## > Product Change Notification (PCN)

<b>Product group:</b>	<b>SEMIPACK</b>	<b>Rev.:</b>	<b>0</b>
<b>No.:</b>	<b>PN22-004</b>	<b>Adjustments of Rth and Zth for SEMIPACK 1 6th generation modules</b>	<b>14 Feb 2022</b>

SEMIPACK 1 6<sup>th</sup> generation modules

Example of updated  $Z_{th(j-c)}(t)$  curve for SKKT 107/16 E:

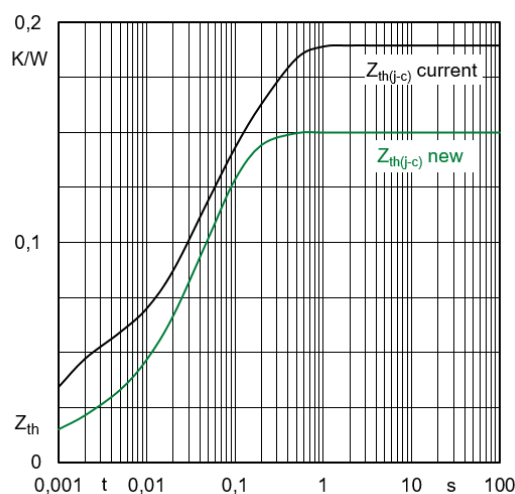
2) Adjustments of  $Z_{th}(t)$  curves along with new steady state values of  $R_{th(j-c)}$  for continuous operation. There is no change of the thermal resistance for current waveforms  $\sin 180^\circ$  and  $\text{rec}120^\circ$ . The module ratings  $I_{TAV}$ ,  $I_{FAV}$  remain unchanged.

For new  $Z_{th}(t)$  curves, updated coefficients of the Foster model are listed in separate document.
